N5227A-01A

S E R V I C E N O T E

Supersedes:
N5227A-01

N5227A PNA Series Microwave Network Analyzers

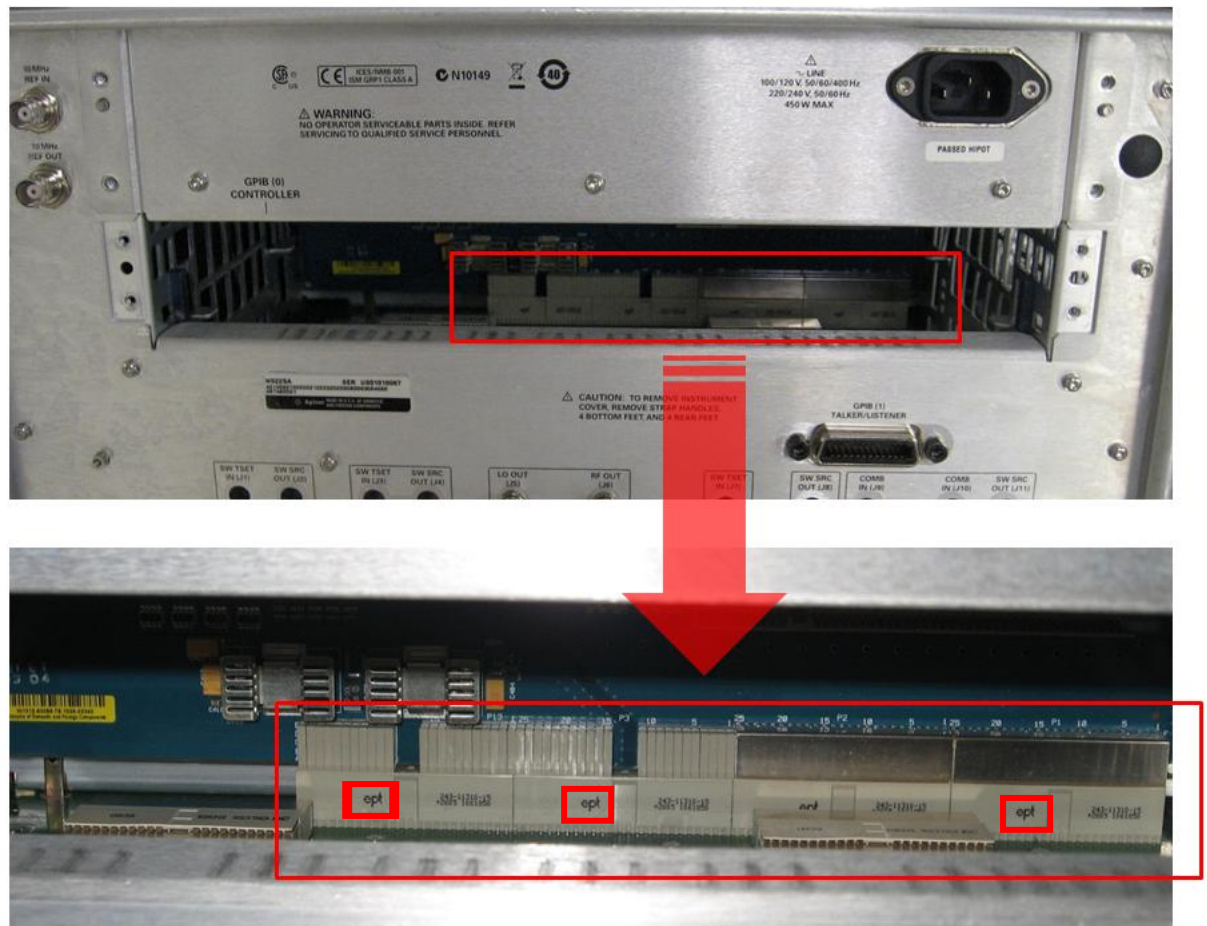
1. Remove the CPU assembly from the analyzer's rear panel. Refer to the PNA Service Guide chapter 7 section titled, "Removing and Replacing the CPU Board Assembly" for removal and reinstallation procedures. To view the online Service Guide, see the numbered list on the next page for instructions.
2. As per the photo below, inspect the system motherboard connector to see if it has one or more "ept" logos.

3. If the connector has one or more “ept” logos, return the analyzer to Agilent for replacement of the system motherboard. If the connector does not have one or more “ept” logos, email ctd-soco_support@agilent.com, providing the analyzer model and serial number and details of the malfunction symptoms.

4. *For Agilent Service Technicians only:* Only new boards without “ept” logos should be installed. Before installing the new board, look to see if it has one or more “ept” logos. If so, email ctd-soco_support@agilent.com, providing the analyzer model and serial number. Wait for further instructions in an email reply. New boards without “ept” logos can be installed. For installation instructions, refer to the PNA Service Guide chapter 7 section titled, “Removing and Replacing the System Motherboard.” To view the online Service Guide, see the numbered list on the next page for instructions.
